City of Eustis

TO: Eustis City Commission

DATE: September 5, 2024

RE: Resolution Number 24-70: Preliminary Subdivision Plat for Eustis SR 19 Subdivision, A 275-unit Townhome Residential Subdivision on approximately 51.87 acres of property, located on the west side of Kurt Street, west of West Charlotte Avenue (Alternate Key Numbers: 2930497 and 3859180)

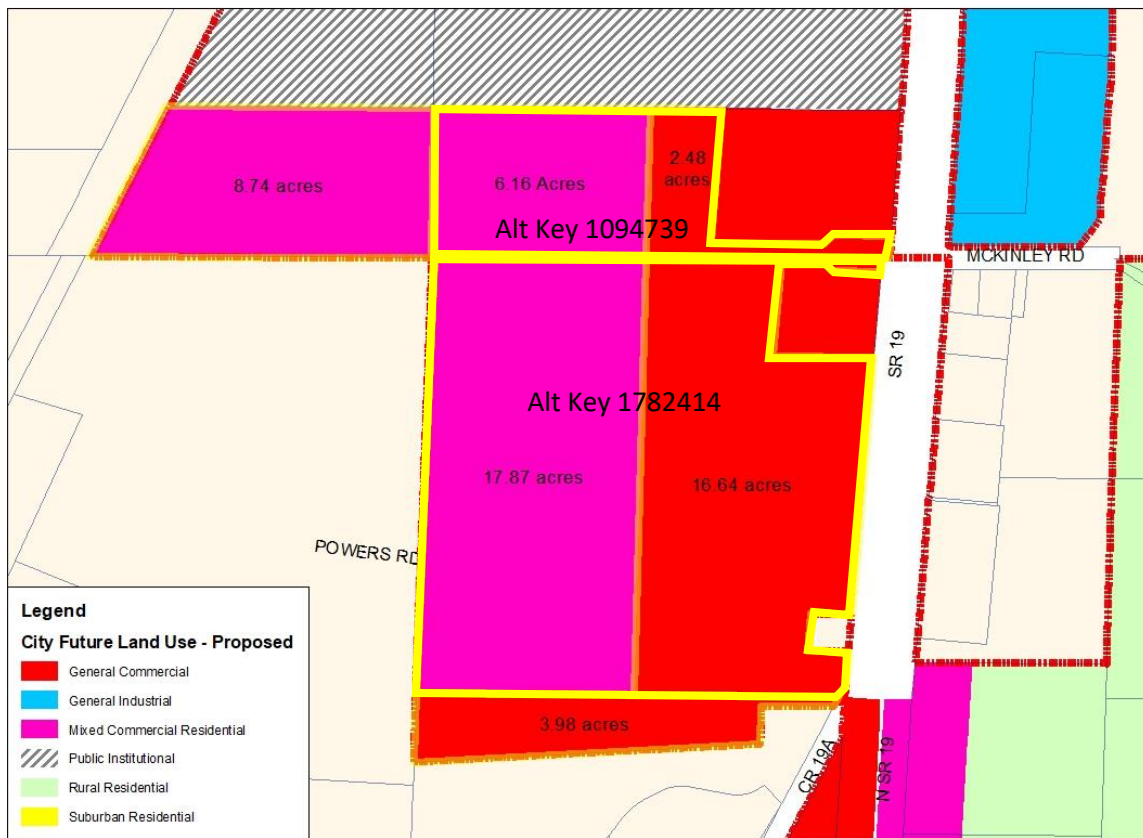
Staff reviewed the land use split for the properties involved in this request and determined that the Mixed Use Commercial Residential Land Use District may apply.

The two parcels that are covered by more than one future land use are Alternate Key Number 1094739 and 1782414. Both of these properties are within the Mixed Commercial Residential (MCR) and General Commercial (GC) land use districts.

Parcel Alternate Key 1094739 has 6.16 acres of its area within the MCR and 2.48 acres within the GC. Per Section 102-15, the MCR district may be applied as the Future Land Use for this parcel. Parcel Alternate Key 1782414 has 17.87 acres of its area within the MCR and 16.64 acres within the GC. Per Section 102-15, the MCR district may be applied as the Future Land Use for this parcel.
